CONSTRUCTION STORMWATER GENERAL PERMIT INSPECTION REPORT

State of Washington Department of Ecology

Ecology Inspector(s): Evan Wood Joe McCord Jacob Neuharth Angela Vincent	On-Site Representative Name: n/a Title: Phone: Email:	Inspection Date and Entry/Exit Time: November 18, 2022, 09:43/10:02	Inspection Type: Unannounced
		Receiving waters: Existing stormwater facility.	Permit webpage: WAR308378

The Woodbrook Townhomes project is covered under the State of Washington's Construction Stormwater General Permit (CSWGP). The CSWGP is a National Pollutant Discharge Elimination System (NPDES) and a State Waste Discharge permit for discharge of construction-related stormwater. The purpose of this inspection is to conduct a compliance inspection and to provide technical assistance as appropriate.

Photo 1

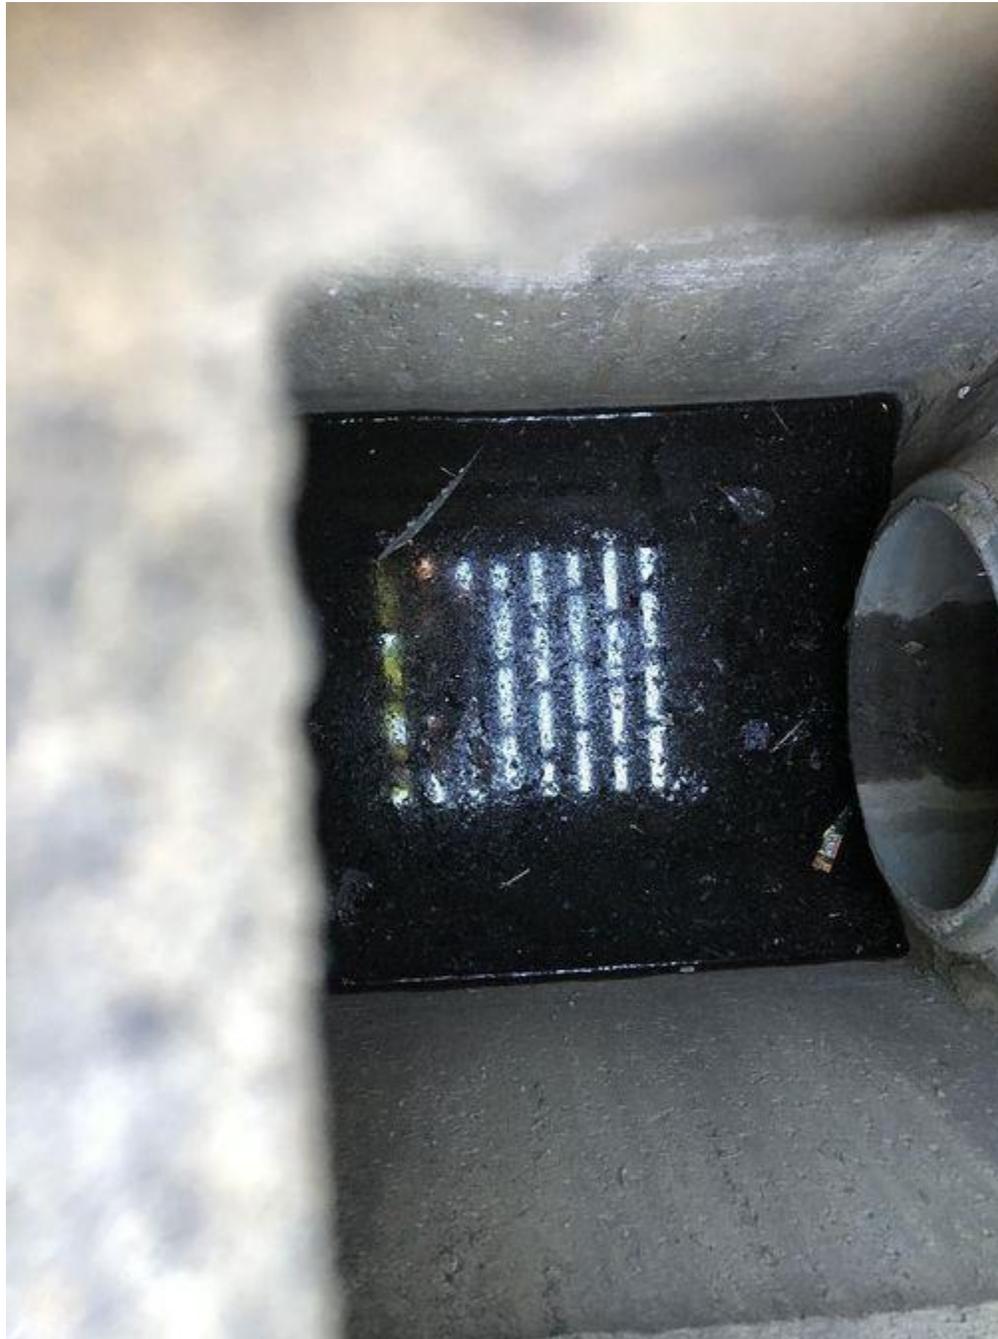
<u>Violations and action required to achieve compliance</u>	<u>Complete or submit date</u>	<u>Guidance</u>
<p><u>S9.D.7 Protect Drain Inlets</u> Inlet protection should be left in place until the site is ready to submit a Notice to Terminate the CSWGP. Failure to meet S9.D.7.a: Protect all storm drain inlets made operable during construction so that stormwater runoff does not enter the conveyance system without first being filtered or treated to remove sediment. Protect and maintain drain inlets, as set forth in permit condition S9.D.7.a.</p>	Immediately begin. Address the problems no later than 10 days from the date of this inspection.	C220

Photo Description: Catch Basins on site no longer have BMP C220: Inlet Protection installed.
